Economic Commission for Europe**Inland Transport Committee****World Forum for Harmonization of Vehicle Regulations****Working Party on Passive Safety****Sixty-sixth session**

UN Regulation No. 17 (Strength of seats)**Proposal for the 10 series of amendments to UN
Regulation No. 17 (Strength of seats)****Submitted by the expert from European Commission***

The text reproduced below was prepared by the experts from the European Commission on behalf of the Stakeholders of Drafting Task Force to transpose UN Global Technical Regulation No. 7, Phase 2 (GTR7-PH2) into UN Regulation No. 17. It is based on a working document ECE/TRANS/WP.29/GRSP/2018/34. The modifications to the current text of the UN Regulation including up to Corrigendum 1 and Supplement 1 to the 09 series of amendments (ECE/TRANS/WP.29/2019/35, and ECE/TRANS/WP.29/2019/116) are marked in bold or strikethrough characters.

Figure 8-14
Measurement of a vertical gap "a". ~~Example of horizontal gaps~~

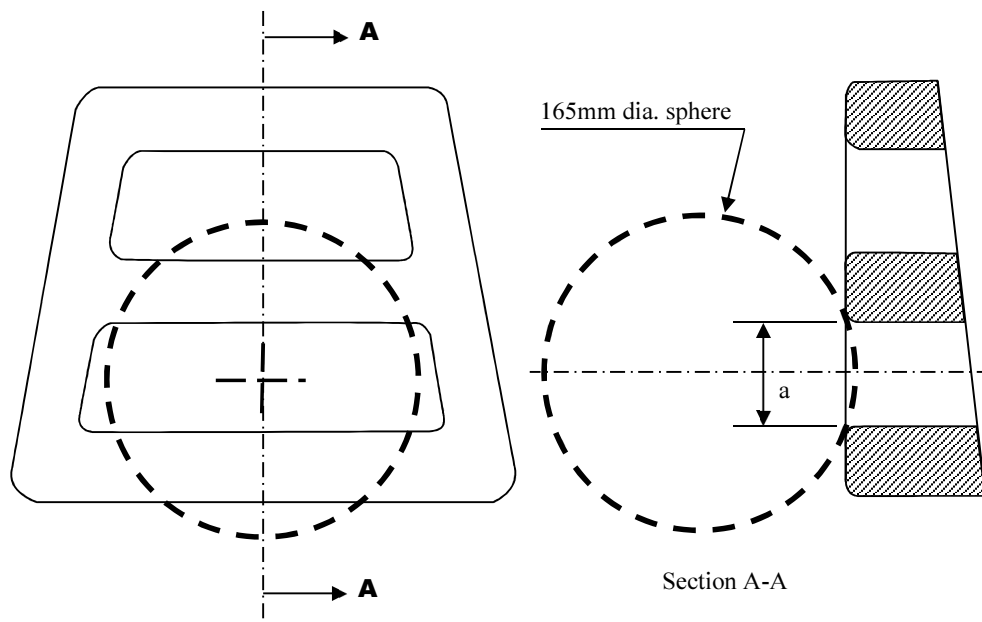
- 2.5. Determine the gap dimension by measuring the straight line distance between the inner edges of the two furthest contact points, as shown in Figures 8-1 and 8-2.

Note: Section A-A is to be made in a point of the gap area which allows the maximum sphere intrusion, without exerting any load.

Figure 8-22
Measurement of a horizontal gap "a".

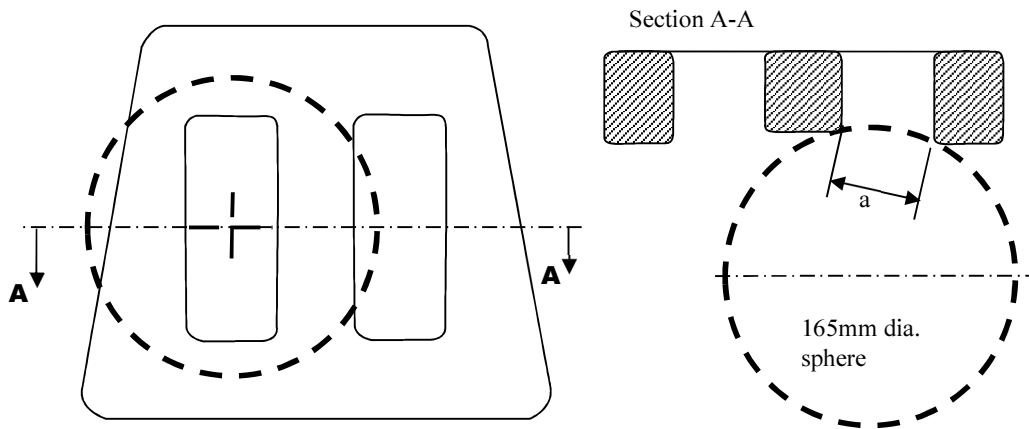
Note: Section A-A is to be made in a point of the gap area which allows the maximum sphere intrusion, without exerting any load.

Figure 9-3

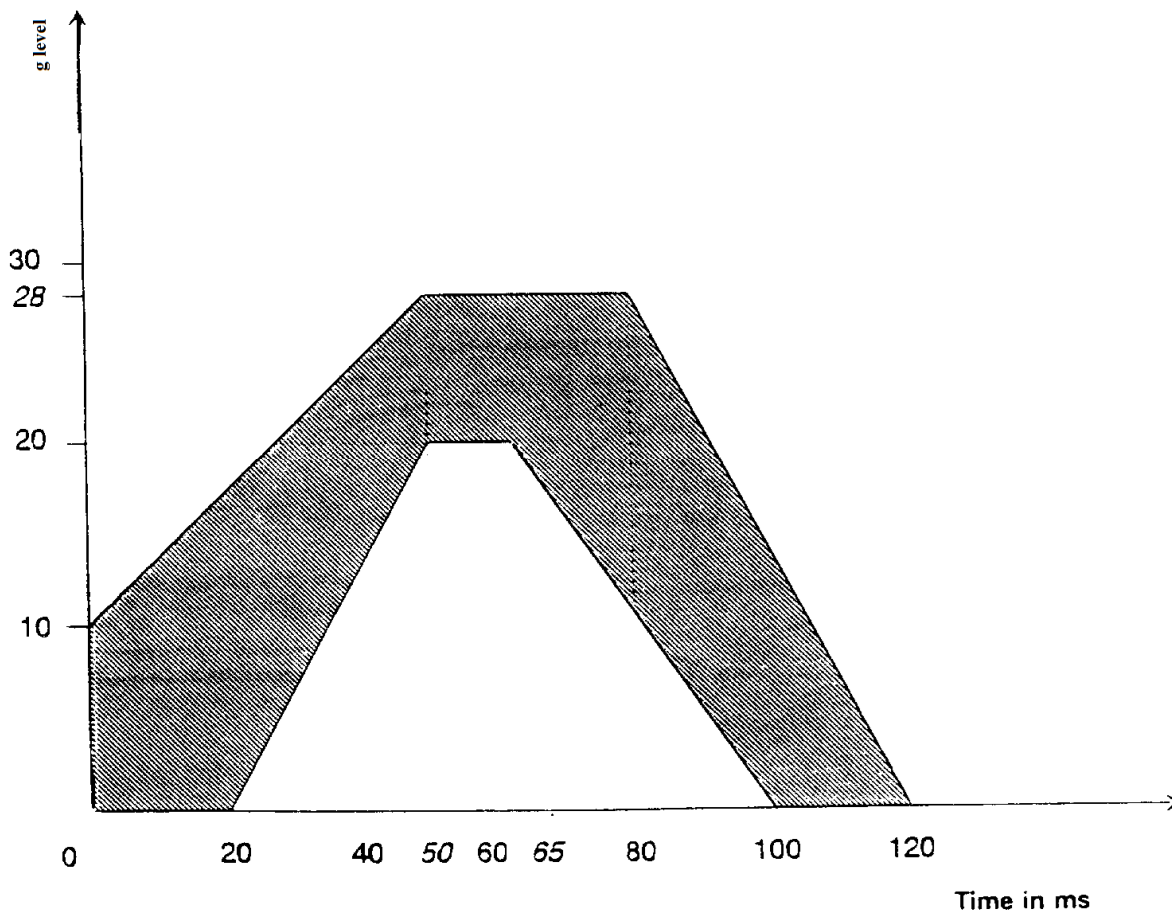
Remember Figure as Figure 9-3, to read:
